**MEMORANDUM**

**FROM:** Anna Chamberlin  
Project Review Manager

**SUBJECT:** **BZA Case No. 19748 – 2430 K Street NW**

**Figure 1 – Student Drop-Off and Pick-Up Plan (provided by the Applicant)**

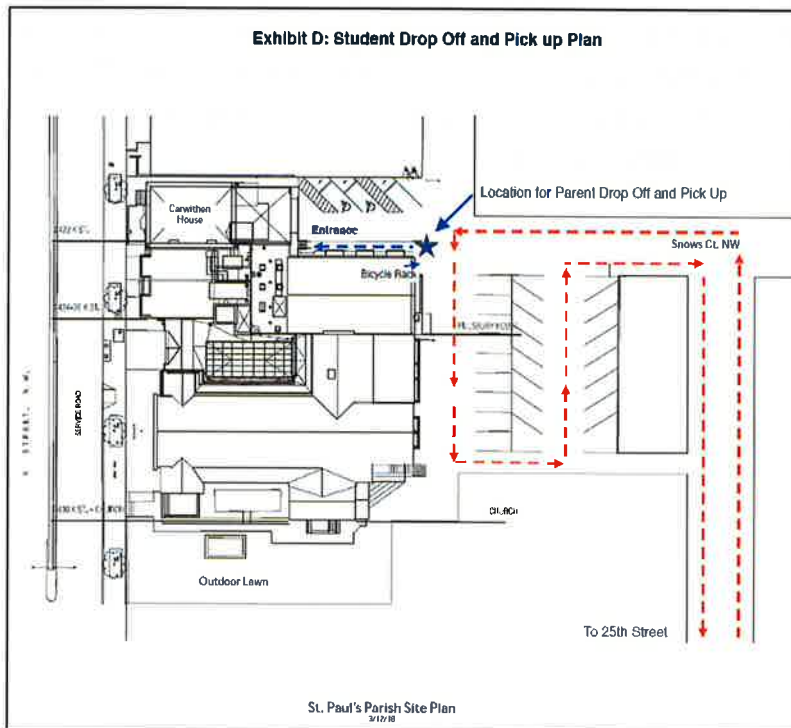
The Applicant provided DDOT with a satisfactory pick-up and drop-off plan. Parents will enter the parking area via the Snows Court alley and circulate around the existing church parking lot. Children will not be permitted to exit their vehicles unless directly in front of the school's back-entrance, where greeters from staff will be present. Parents that need to escort students into the building will temporarily park in the church lot. Figure 1 below shows the vehicle circulation pattern for pick-ups and drop-offs.

As afternoon departures will be staggered between 3:00 PM and 6:00 PM, DDOT anticipates more intensive vehicle operations during the morning drop-off period, which will occur between 8:00 AM and 8:45 AM.
